**January 8, 2018**  
**BOARD OF COUNTY COMMISSIONERS**  
**ORANGE COUNTY, FLORIDA**  
**Y18-725-TA / ADDENDUM # 2**  
**EASTERN REGIONAL WATER SUPPLY FACILITY IMPROVEMENTS PHASE IIIB**

**Bid Opening Date: January 25, 2018**

**E403**

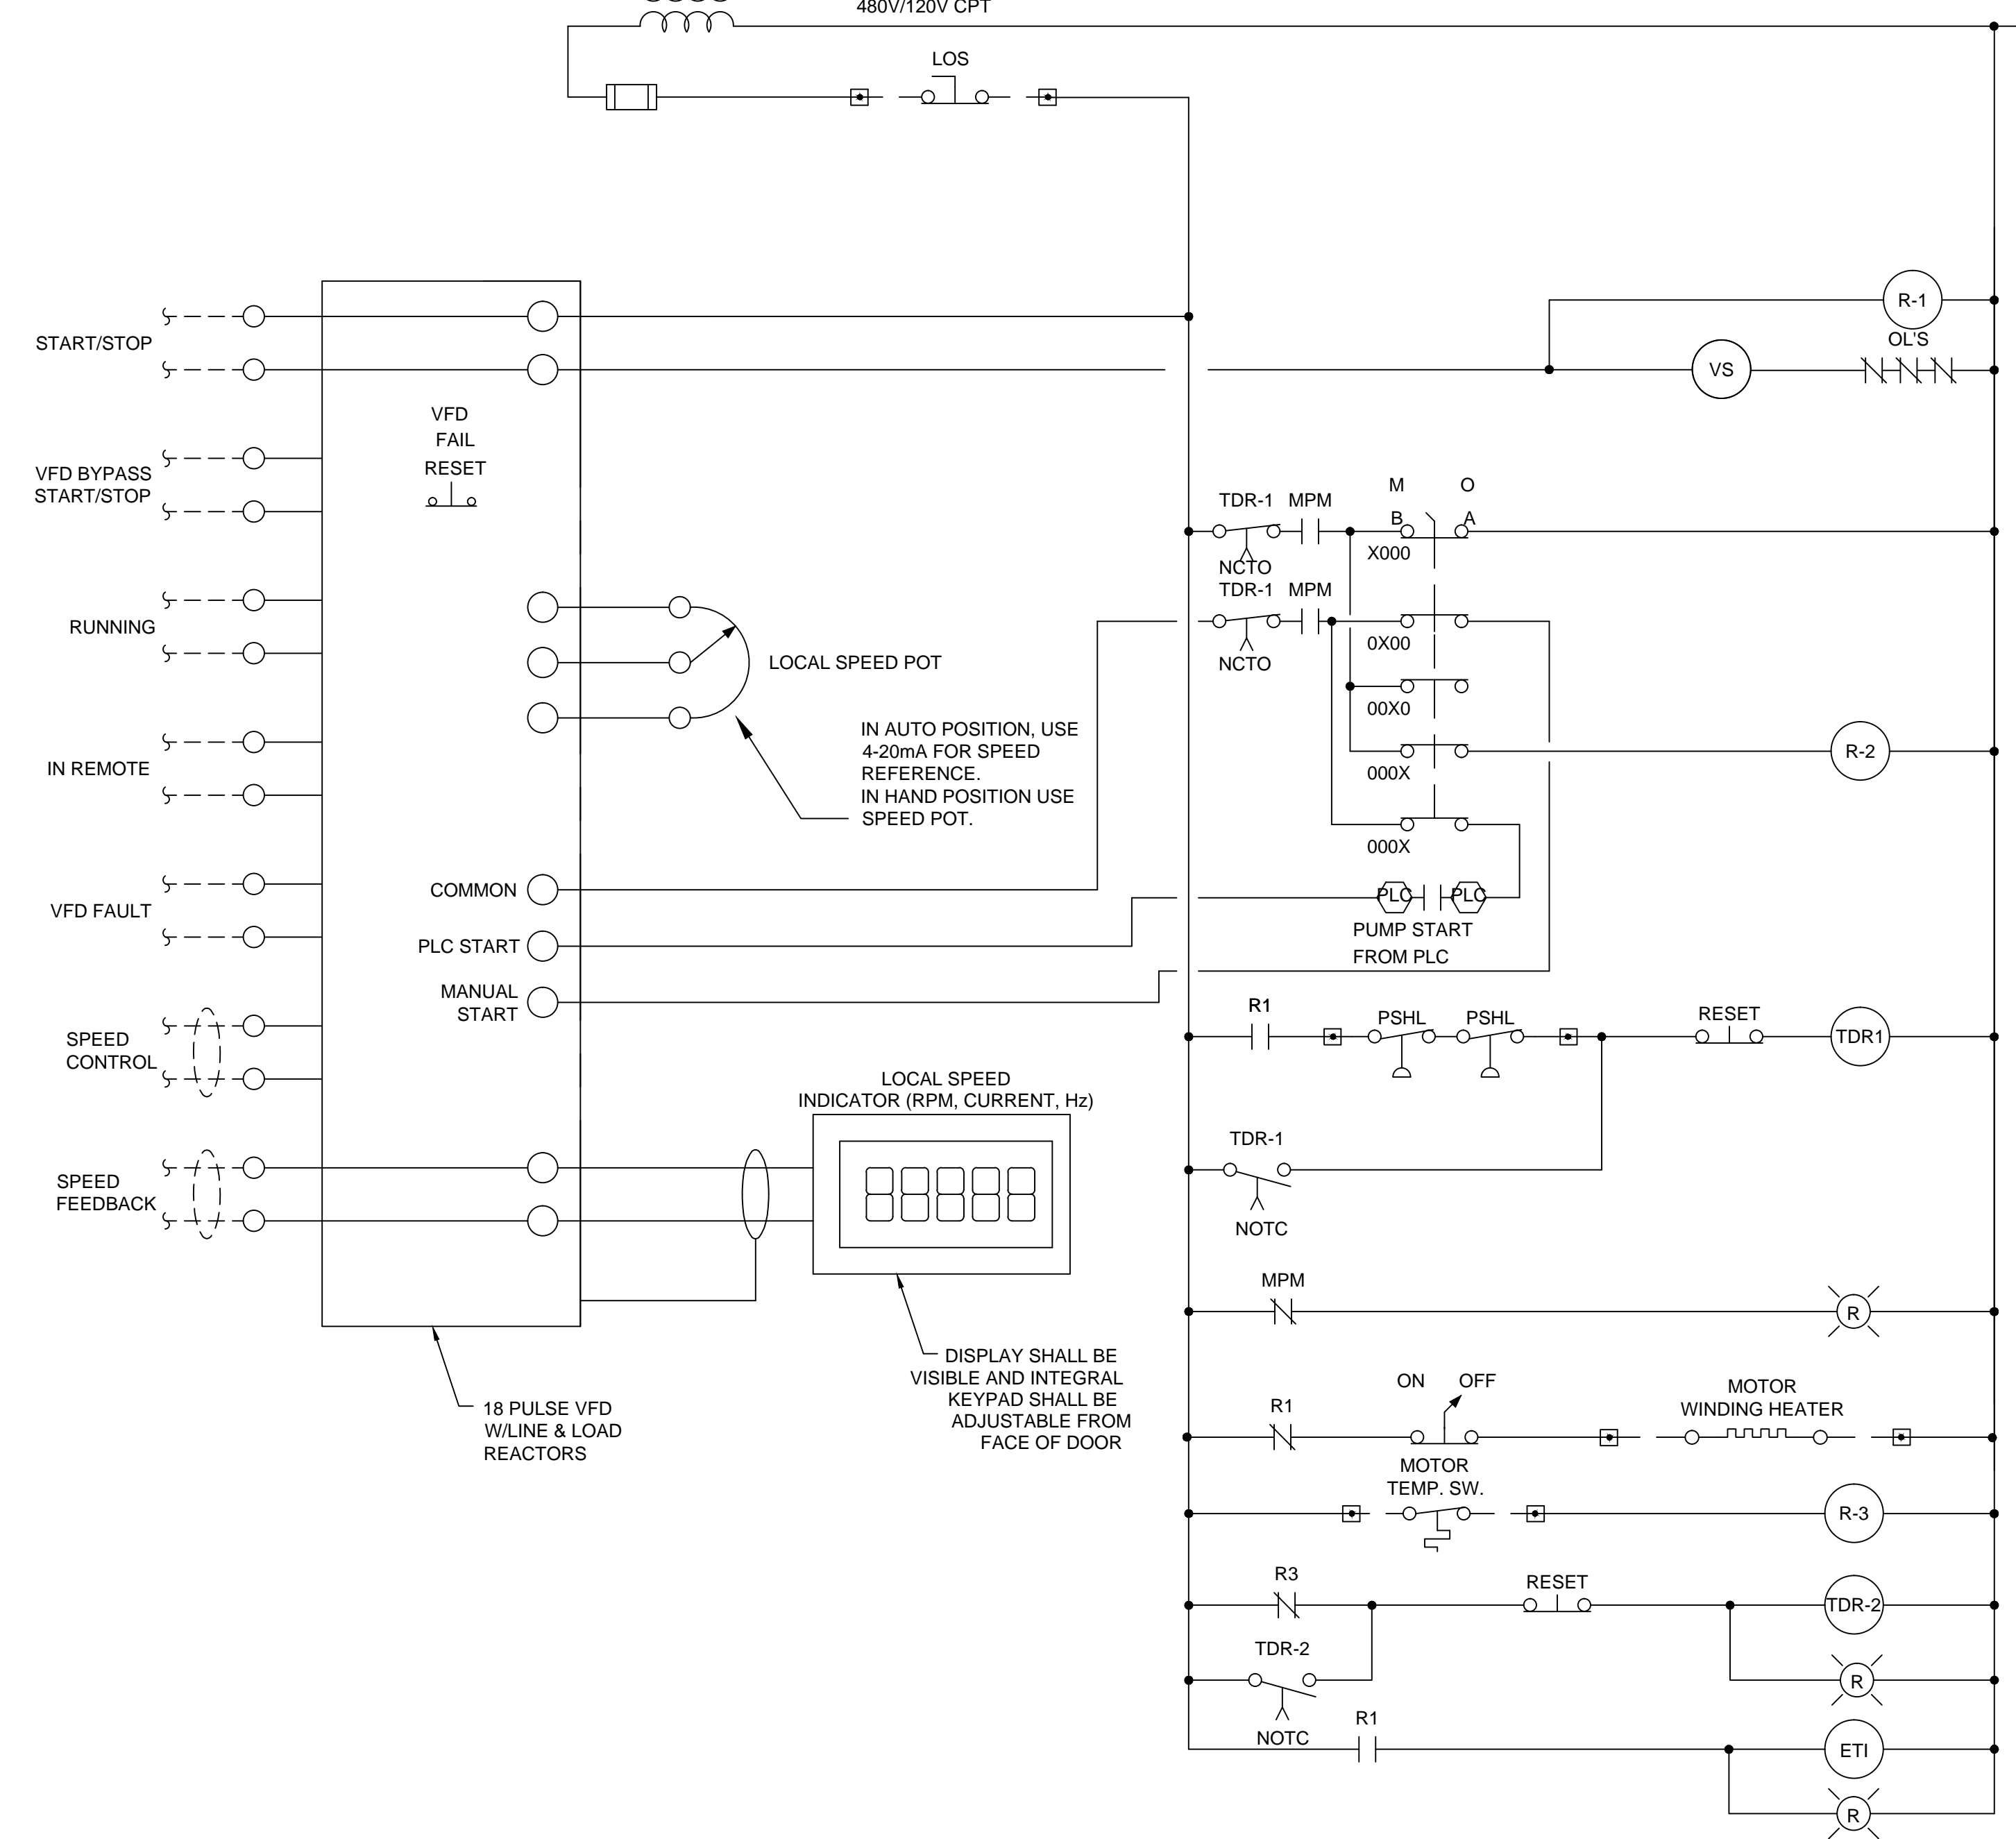
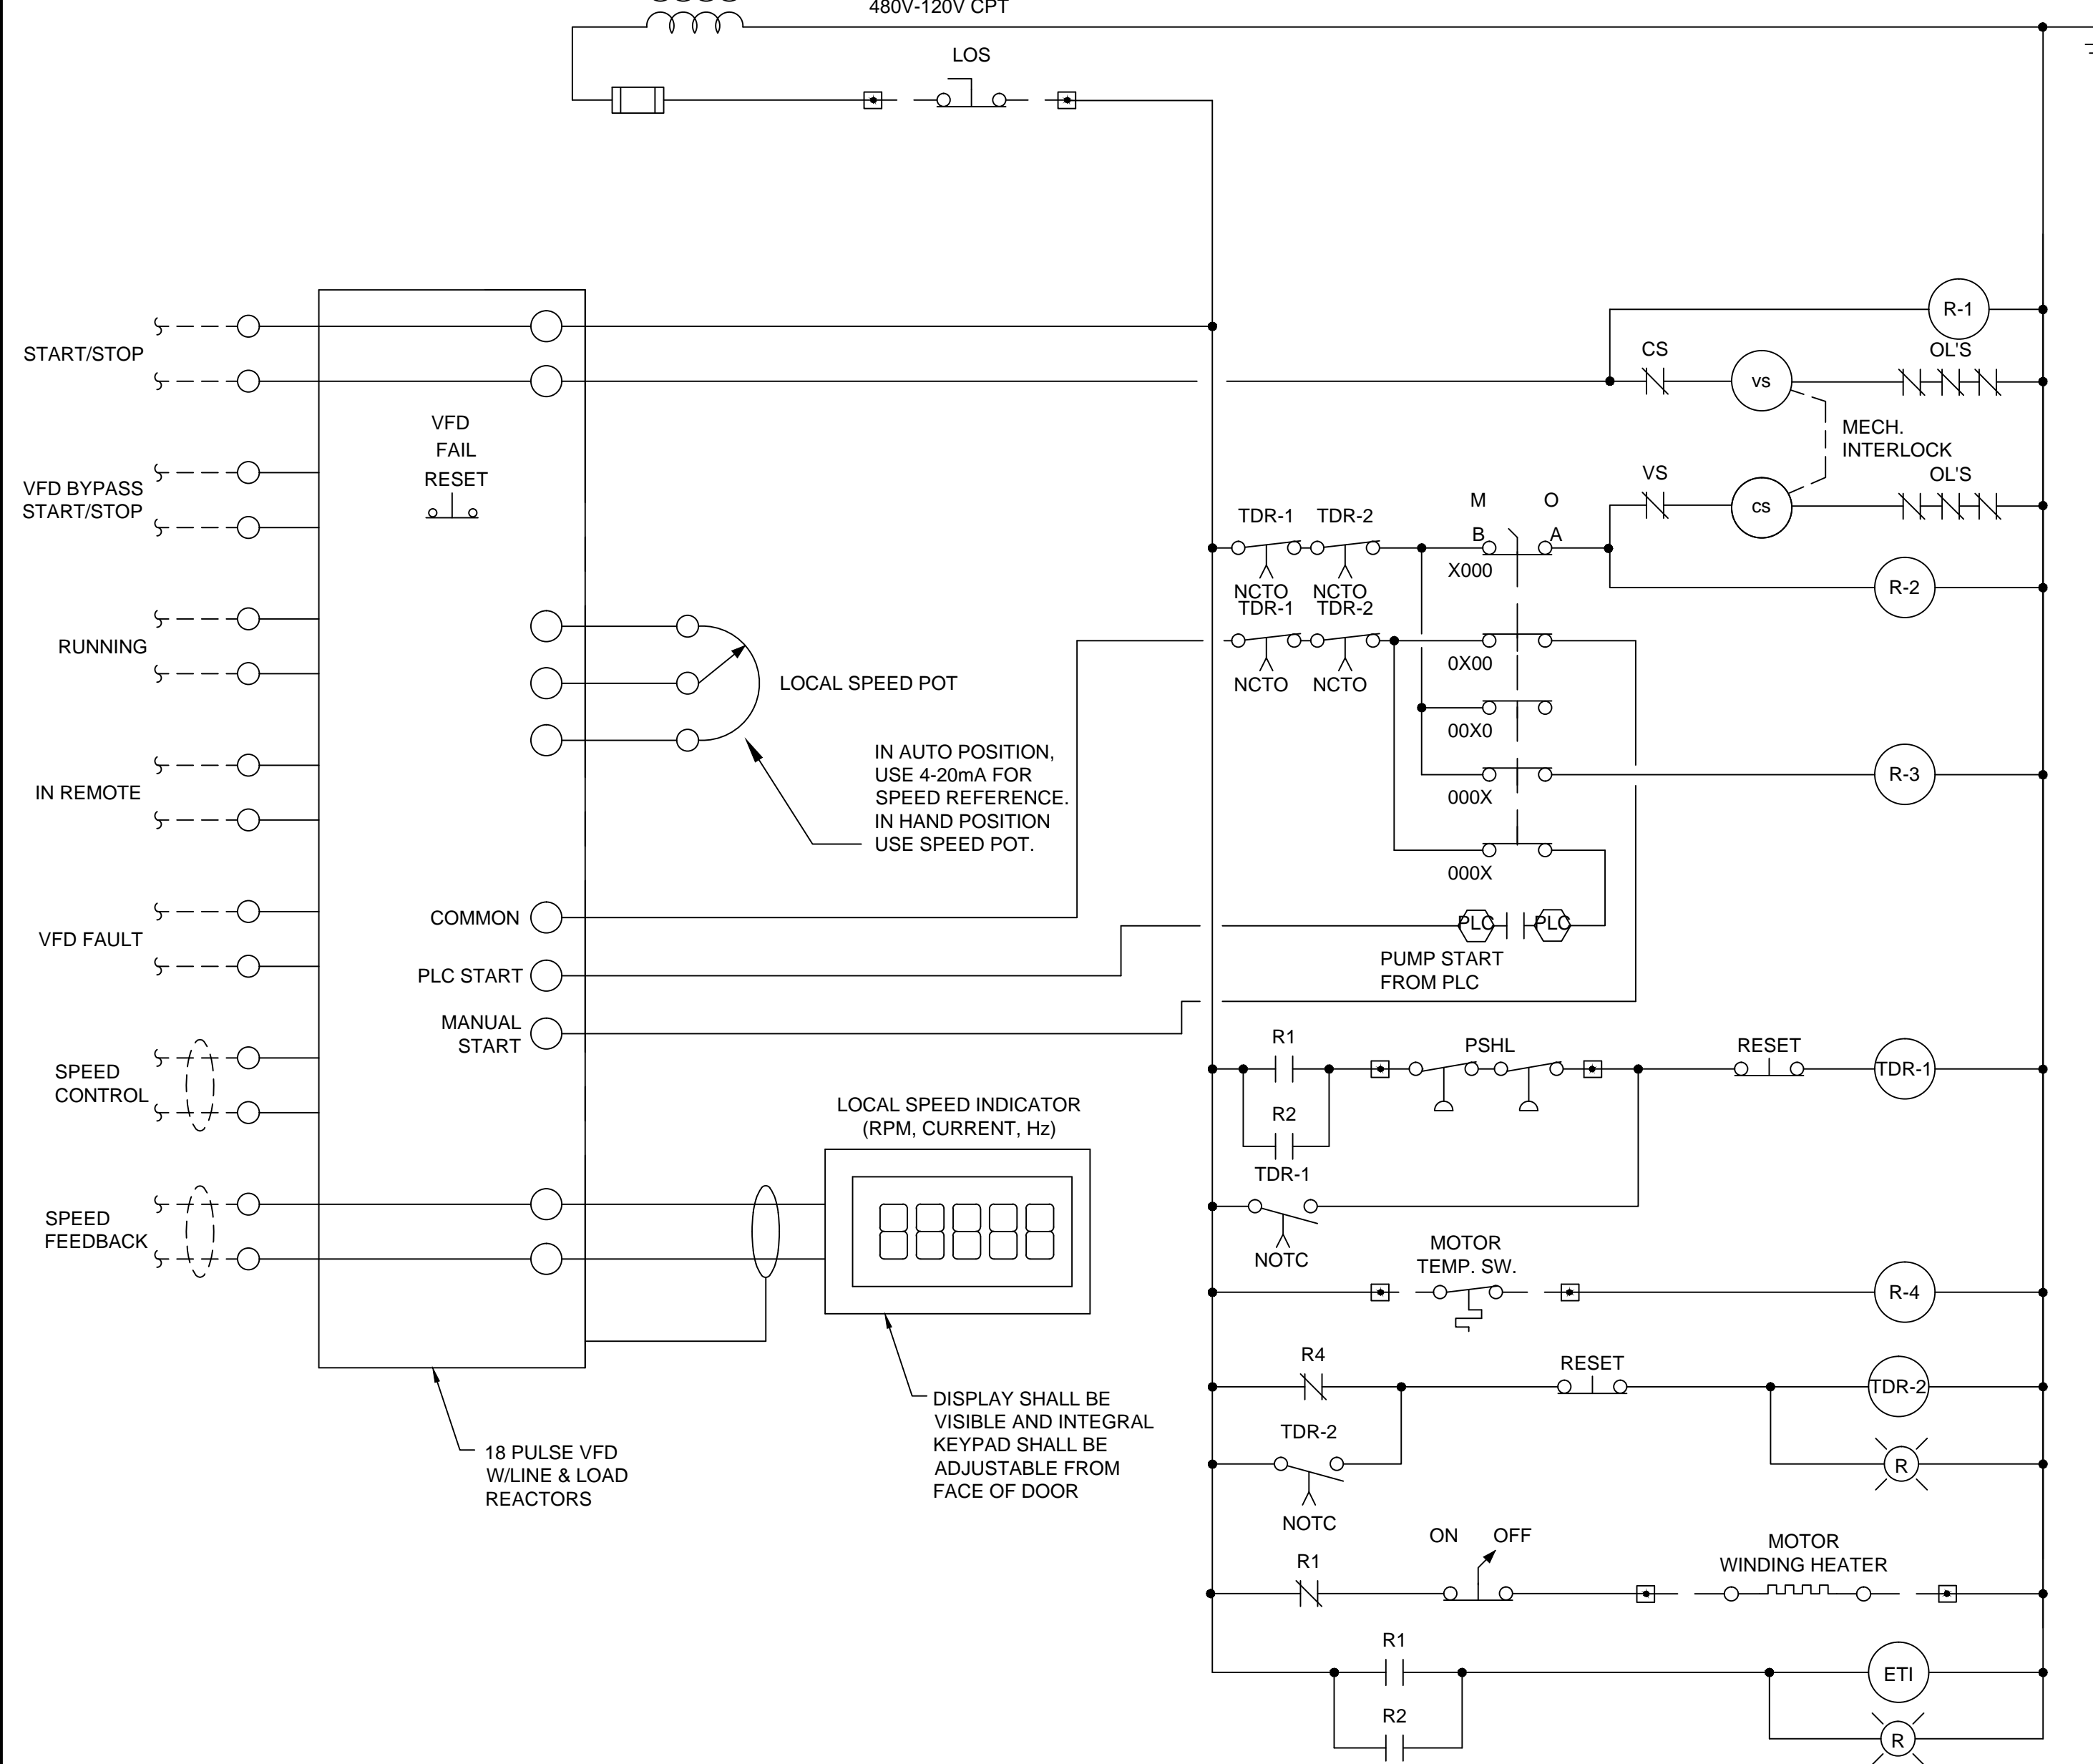
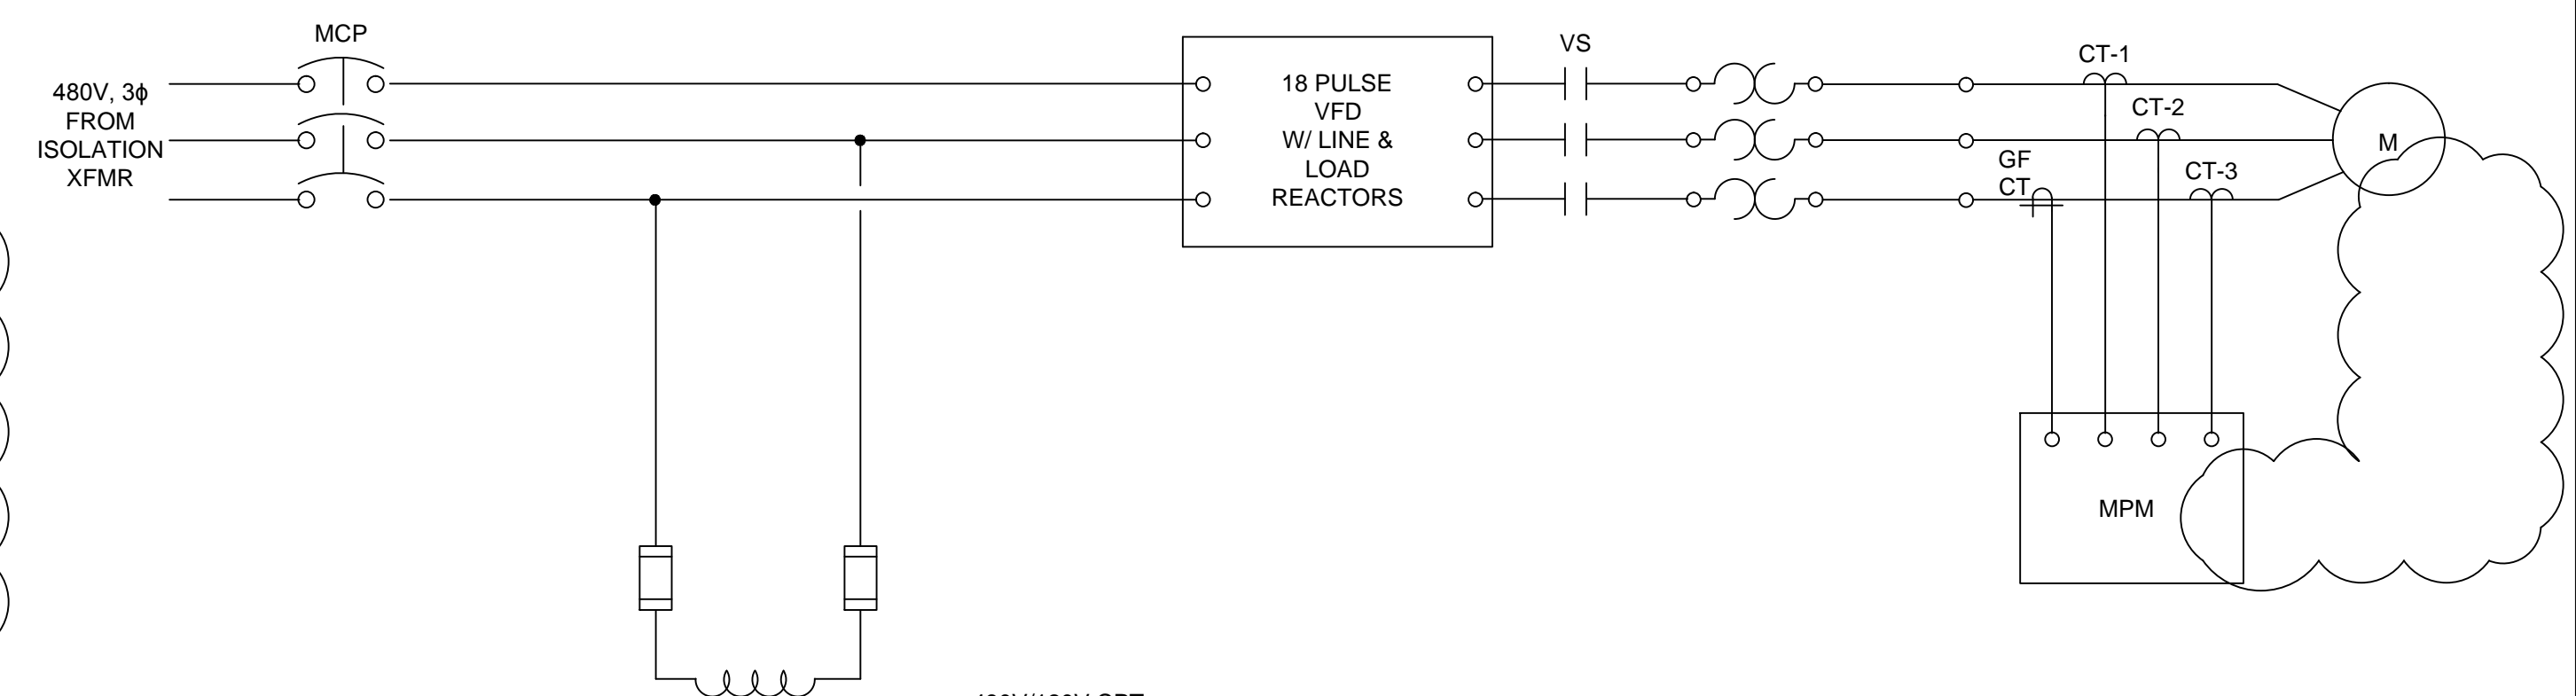
- 3. Drawing Sheet E403, Replace Drawing Sheet E403 Wiring Diagrams with the attached Revised Drawing Sheet E403 Wiring Diagrams.**
  - 4. Drawing Sheet I309, Delete Note No. 1 in its entirety.**
- E.** All other terms, conditions, and specifications of the IFB remain unchanged.
- F.** The Bidder shall acknowledge receipt of this addendum by completing the applicable section in the solicitation or by completion of the acknowledgement information on the addendum. Either form of acknowledgement must be completed and returned not later than the date and time for receipt of the bid.
